The Commission has issued the enclosed Amendment Nos. 69, 65 and 41 to Facility License Nos. DPR-33, DPR-52 and DPR-68, respectively, for the Browns Ferry Nuclear Plant, Units Nos. 1, 2 and 3. These amendments consist of changes to the Appendix B Environmental Technical Specifications in response to your request dated August 29, 1979 (TVA BFNP TS 130).

BROWNS FERRY NUCLEAR PLANT, UNIT NO. 2

AMENDMENT TO FACILITY OPERATING LICENSE

Amendment No. 65  
License No. DPR-52

**BROWNS FERRY NUCLEAR PLANT**  
TVA Office of Power  
Organization for Operation  
of Nuclear Plants  
Figure 5.2-1

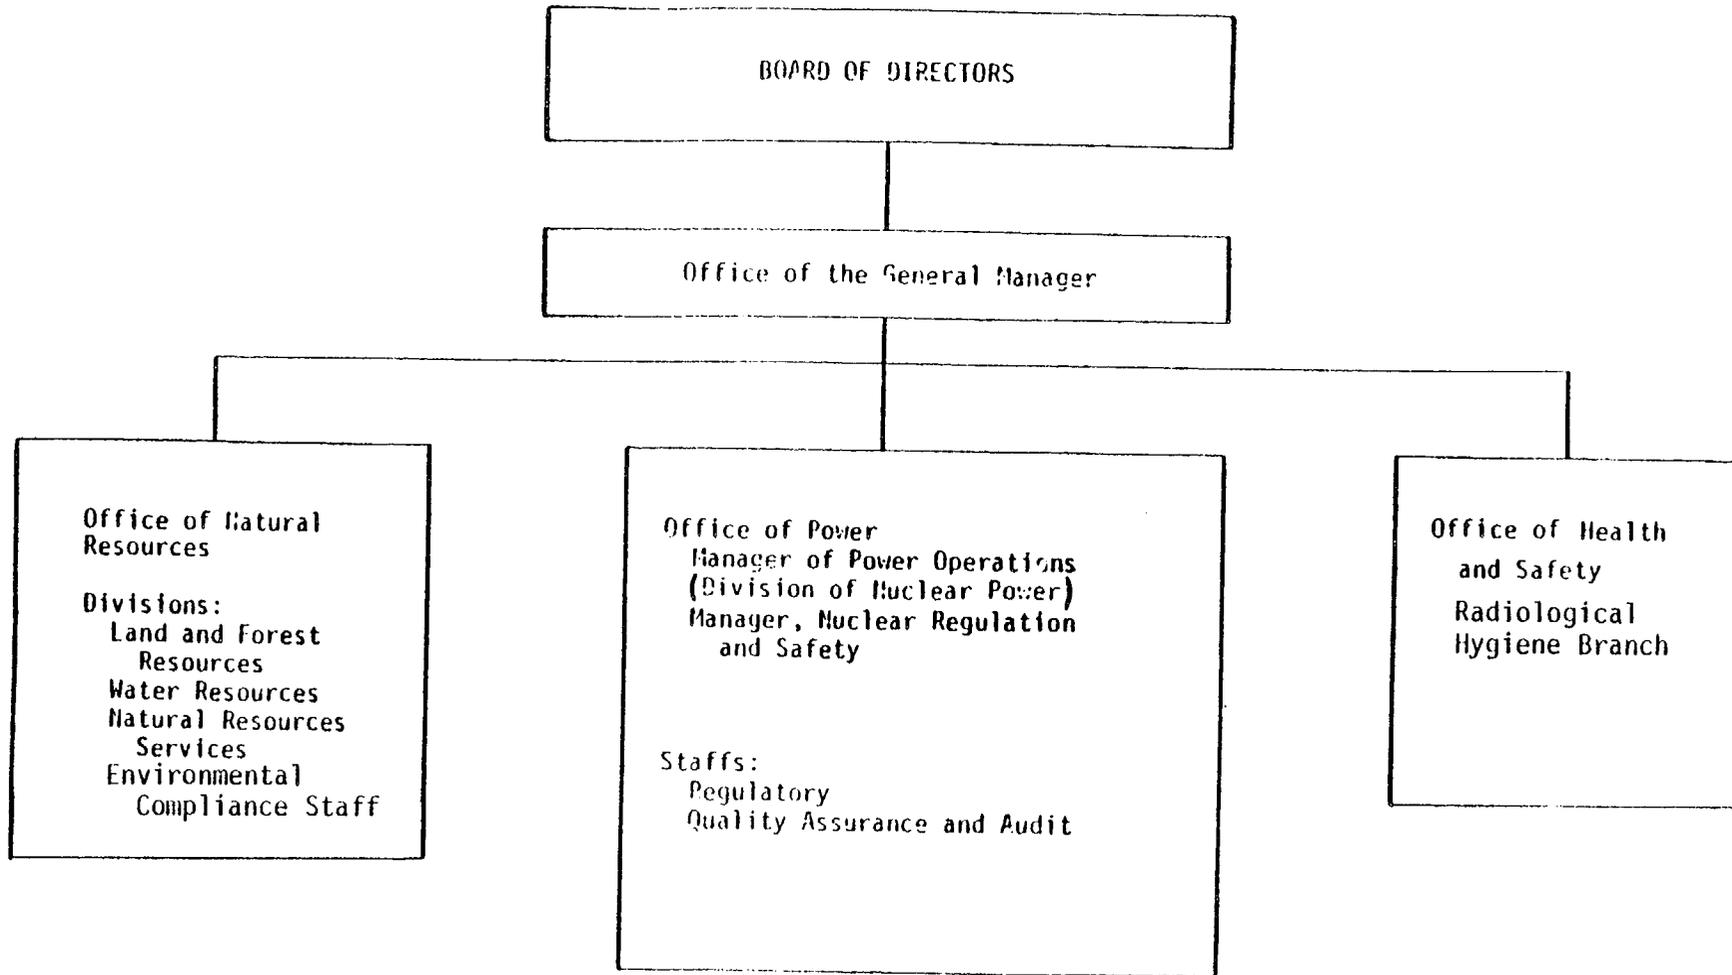
Administrative Controls to change the titles and organizational elements within TVA responsible for environmental activities is being made to reflect recent organizational changes within TVA.

These amendments revise the Environmental Technical Specifications to (1) delete water quality and aquatic monitoring and reporting requirements which duplicate those conditions regulated by the Browns Ferry Nuclear Plant's NPDES Permit No. AL0022080 issued to TVA on June 30, 1977 and (2) change the titles in Section 5.0 (Administrative Controls) for the offices within TVA responsible for environmental activities to reflect recent organizational changes.

- 5.2.1 The organization of TVA management which directly relates to operation of the plant is shown on Figure 5.2-1.
- 5.2.2 The principal organizations within TVA which are concerned with environmental matters related to nuclear power plant operations are the Office of Power, Office of Natural Resources, and the Office of Health and Safety. The Office of Power is directly responsible for operating the plant in accordance with specified requirements and conducting onsite monitoring. The Office of Natural Resources and the Office of Health and Safety are responsible for providing technical guidance, assistance, monitoring, and other services as needed for environmental compliance. The Environmental Compliance Staff is responsible for independent review and audit of procedures for meeting environmental specifications and limits. The organizations above report to the General Manager as shown in Figure 5.2.2.
